WATER PERMIT NO. 7147-3

Application For Permit To Appropriate Water Within The State Of South Dakota

**RECOMMENDATION OF CHIEF ENGINEER FOR WATER PERMIT
APPLICATION NO. 7147-3, James Eveson**

REPORT ON
WATER PERMIT APPLICATION NO. 7147-3
James Eveson
July 7, 2009

JAMES EVENSON
Roberts Co.
NW 1/4 Sec 6, T. 12S R. 51
Water @ 100.2 = 4.3 AC
Top Dam @ 104.1 = 5.3 AC
1" = 75'

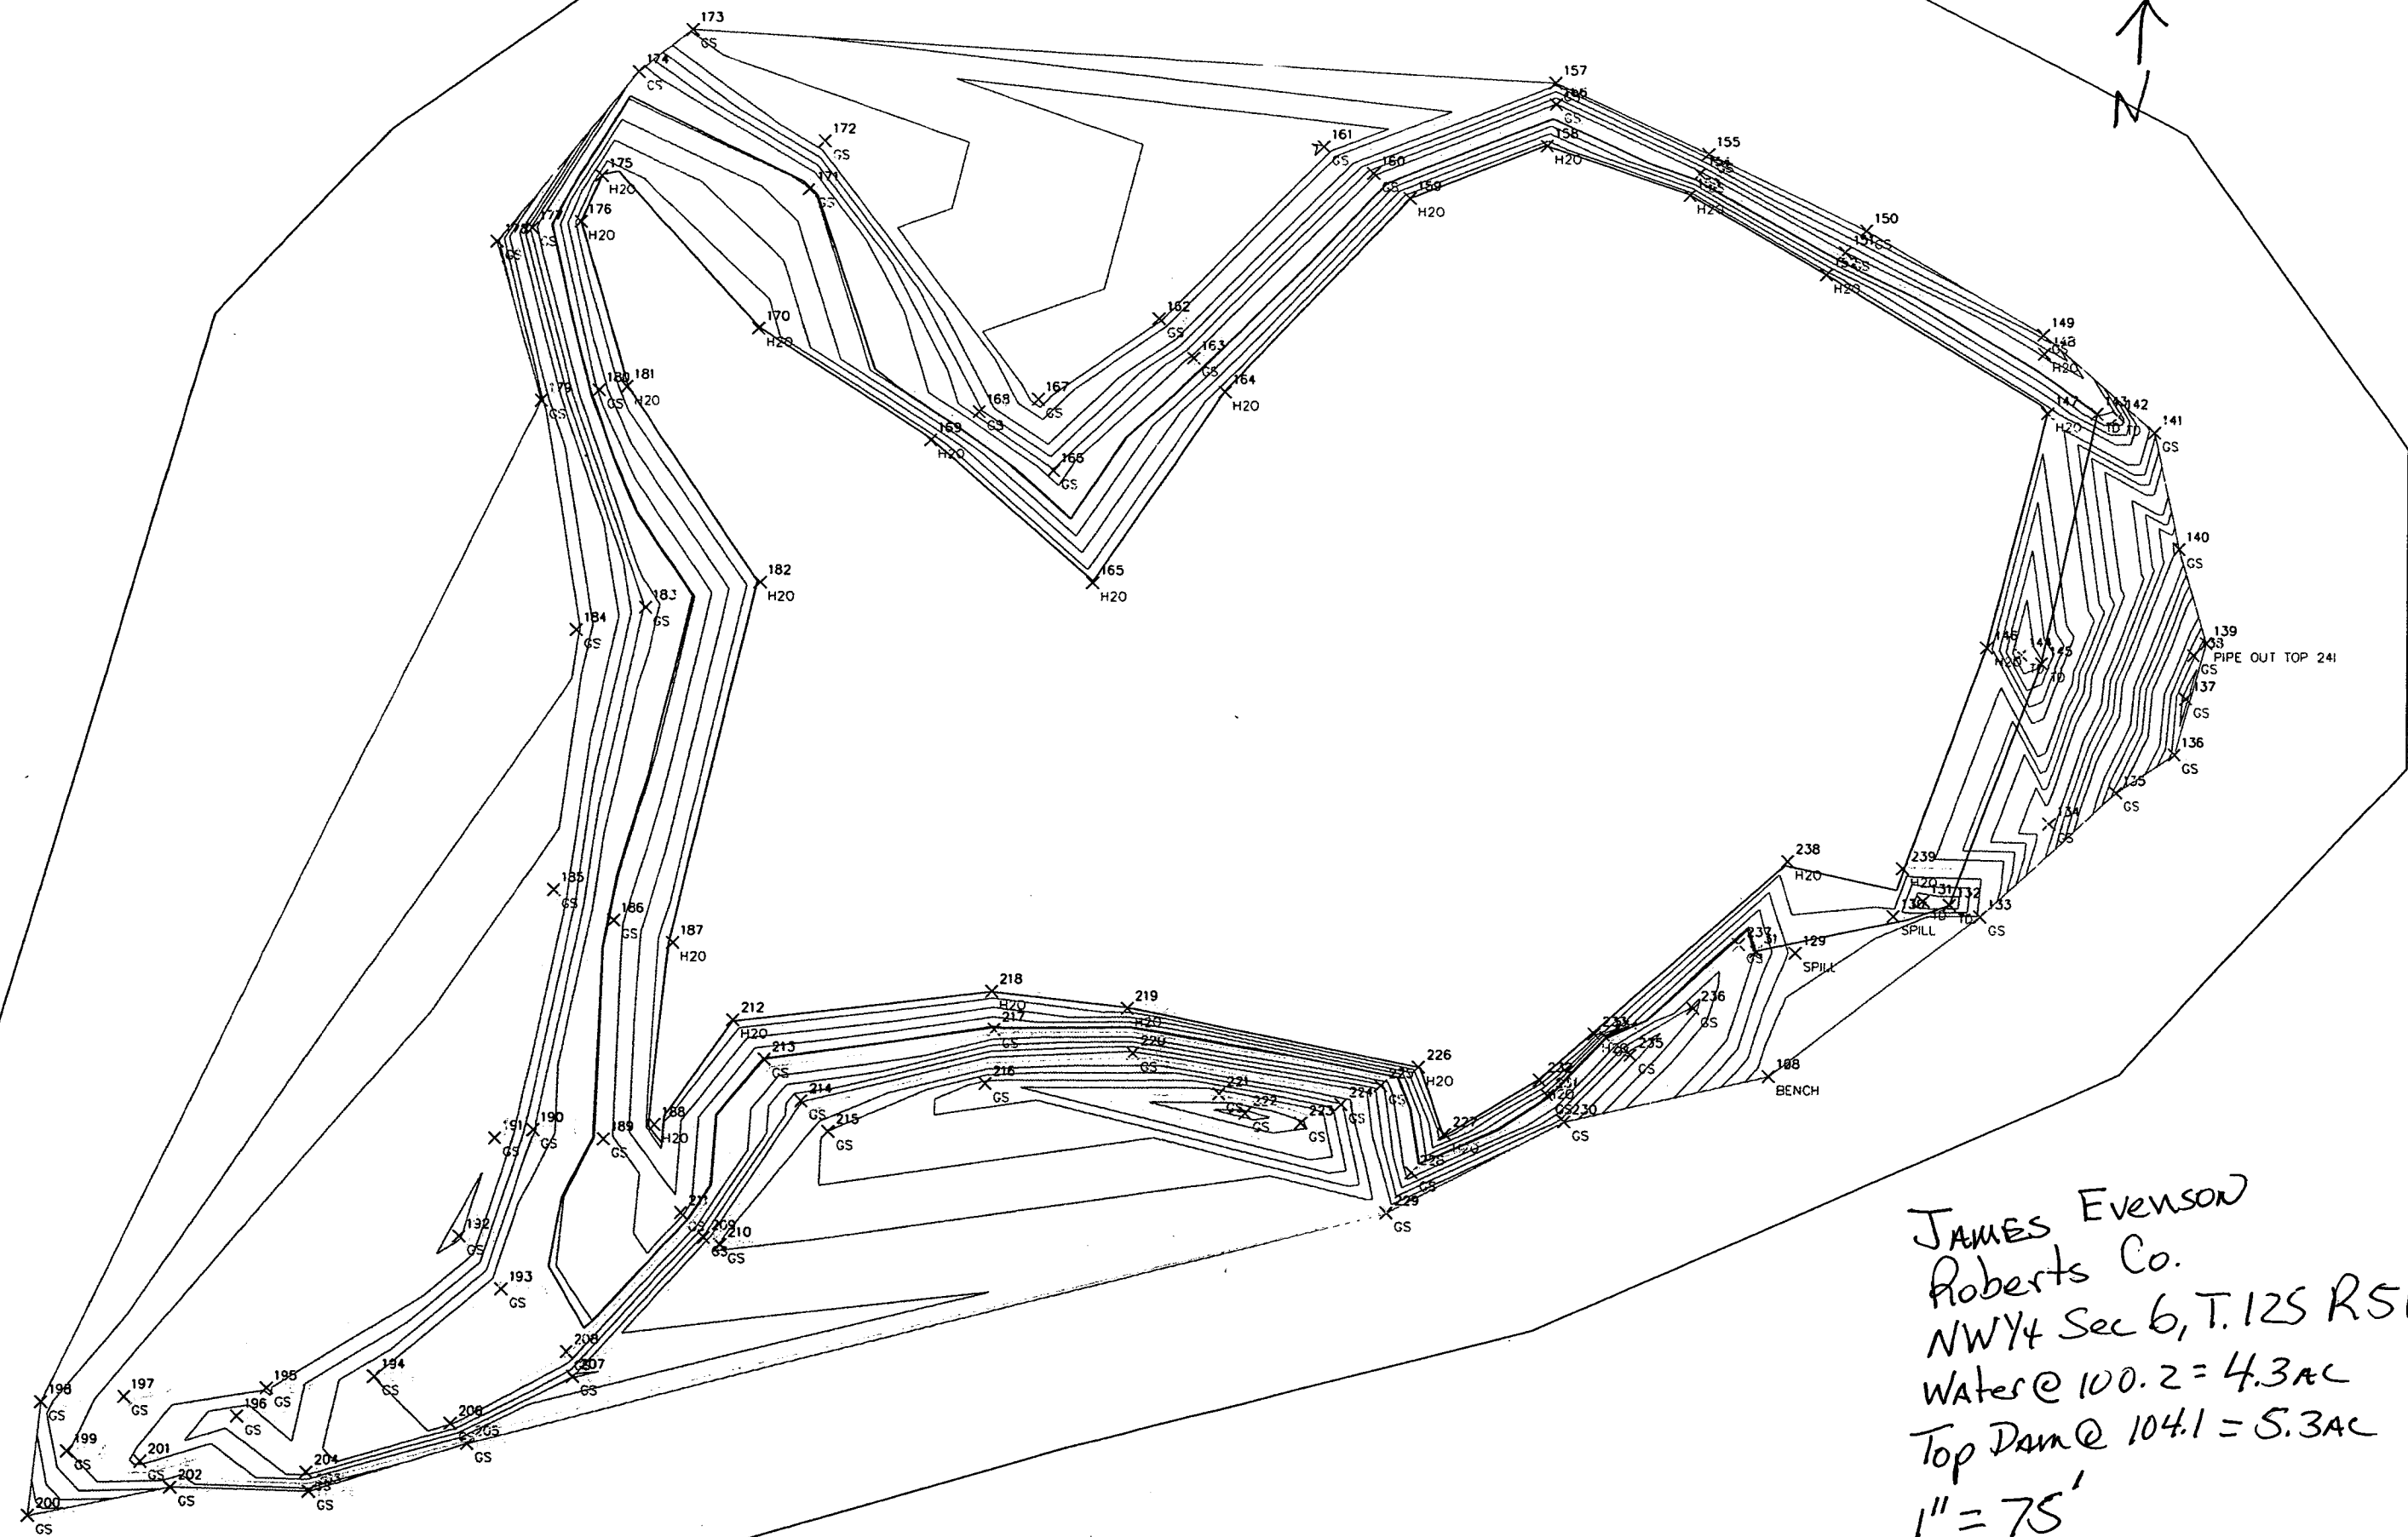
Top of Dam Elev. - 105
2nd Spillway Elev. - 102
P. Spillway Elev. - 99
Dis Emb Toe Elev. - 80.5

Cont. 3 - Low Hazard Dam

Ht. = 24.5 ft

Normal Storage Capacity - 36.7 A-Ft
Int. Storage Capacity - 48.5
Max. Storage Capacity - 65.5

Int. Capacity x Eff Ht. = $48.5 \times 21.7 = 1053 < 3000 \therefore 25 \text{ yr}$
Minimum Spillway Design

1. Topo Map - OK
2. Dam Axis Profile - OK
3. Dam Map X-sec. - OK
4. Area Capacity - OK
5. Outlet Details - OK
6. Spillway Rating - OK
7. Spillway Details - OK
8. Specs - std NRCS - OK
9. EPP - N/A Cal. 3 - OK
